BELMONT MIDDLE AND HIGH SCHOOL BUILDING COMMITTEE

AUGUST 28 2019

VE STRATEGIES - EXTERIOR

ITEM 11 : REMOVE SKYLIGHTS

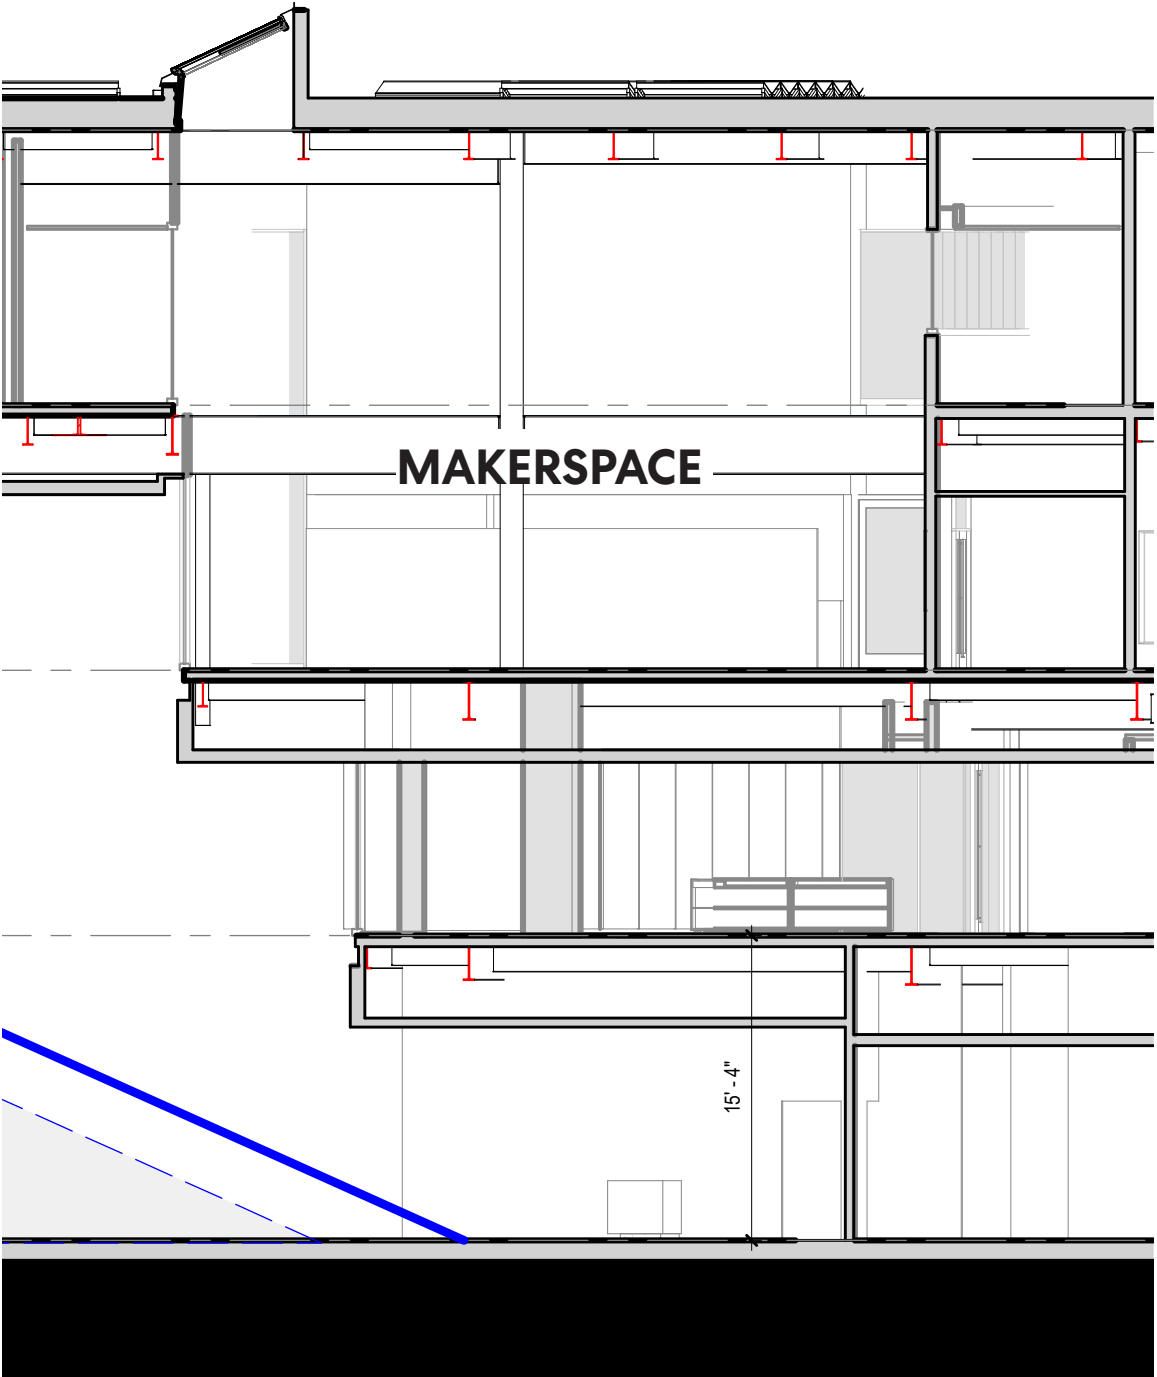
- REMOVE 100% OF SKYLIGHTS FROM MS AND HS ROOFS

ITEM 11 : REMOVE SKYLIGHTS

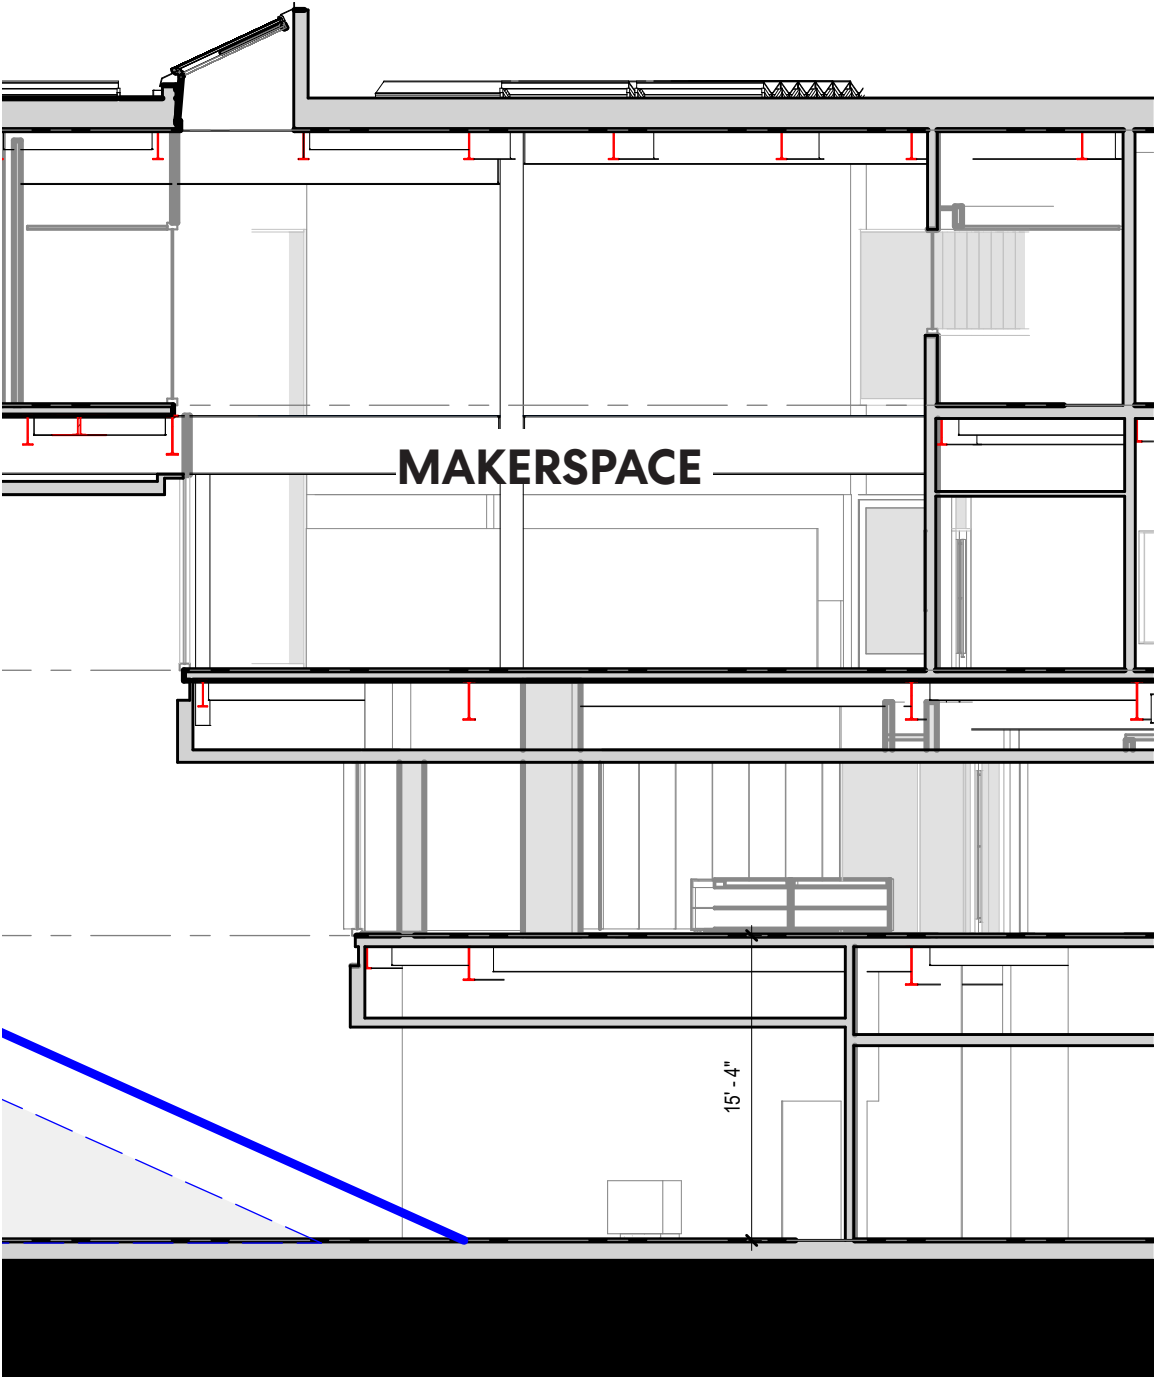
- REMOVE 100% OF SKYLIGHTS FROM MS AND HS ROOFS

ITEM 12: NO REPLACEMENT OF KALWALL AT EXISTING FIELDHOUSE

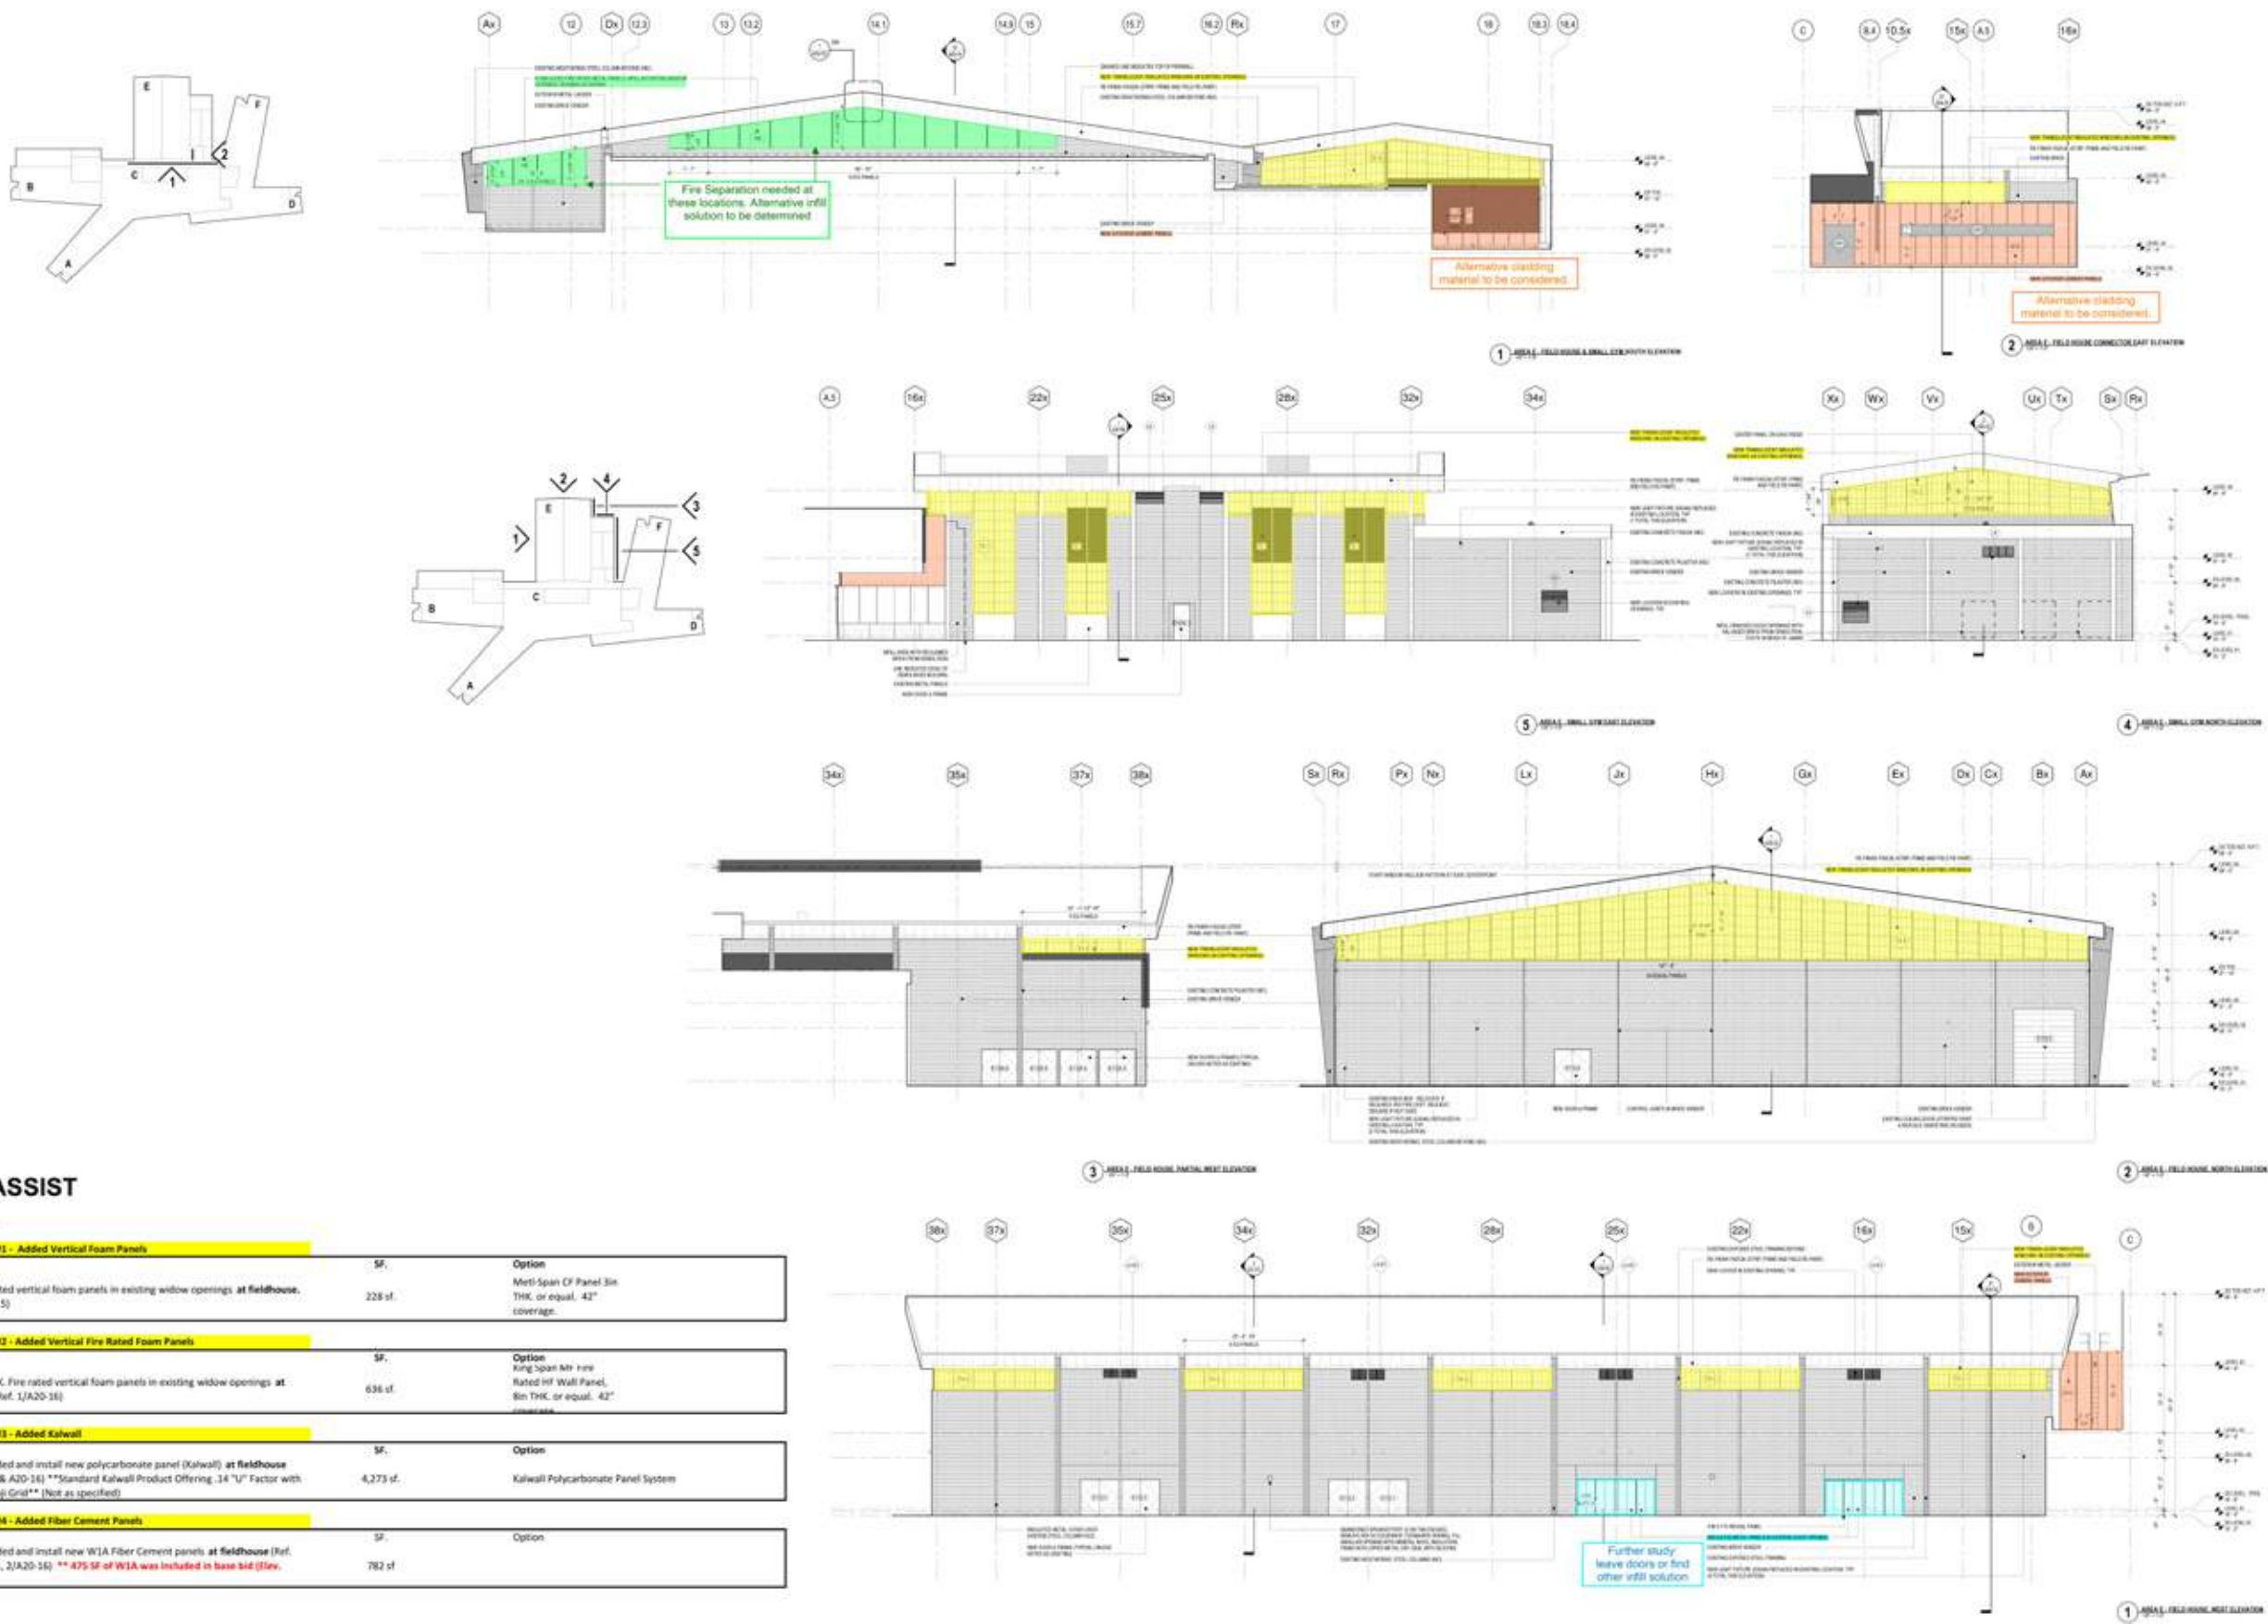
NEW - Item #1 - Added Vertical Foam Panels		
1	Added insulated vertical foam panels in existing widow openings at fieldhouse. (Ref. 1/A20-15)	228 sf. Option: Multi-Span CF Panel 3in THK. or equal. 42" coverage.
NEW - Item #2 - Added Vertical Fire Rated Foam Panels		
2	Added 8" THK. Fire rated vertical foam panels in existing widow openings at fieldhouse. (Ref. 1/A20-16)	636 sf. Option: King Span Air Fire Rated Inf. Wall Panel, 8in THK. or equal. 42" coverage.
NEW - Item #3 - Added Kalwall		
3	Add to provided and install new polycarbonate panel (Kalwall) at fieldhouse (Ref. A20-15 & A20-16) **Standard Kalwall Product Offering .14 "U" Factor with 12" x 24" Shoji Grid** (Not as specified)	4,273 sf. Option: Kalwall Polycarbonate Panel System
NEW - Item #4 - Added Fiber Cement Panels		
4	Add to provided and install new WJA Fiber Cement panels at fieldhouse (Ref. 1/A20-15 & 1, 2/A20-16) ** 475 SF of WJA was included in base bid (Rev. 2/A20-16)	782 sf. Option:
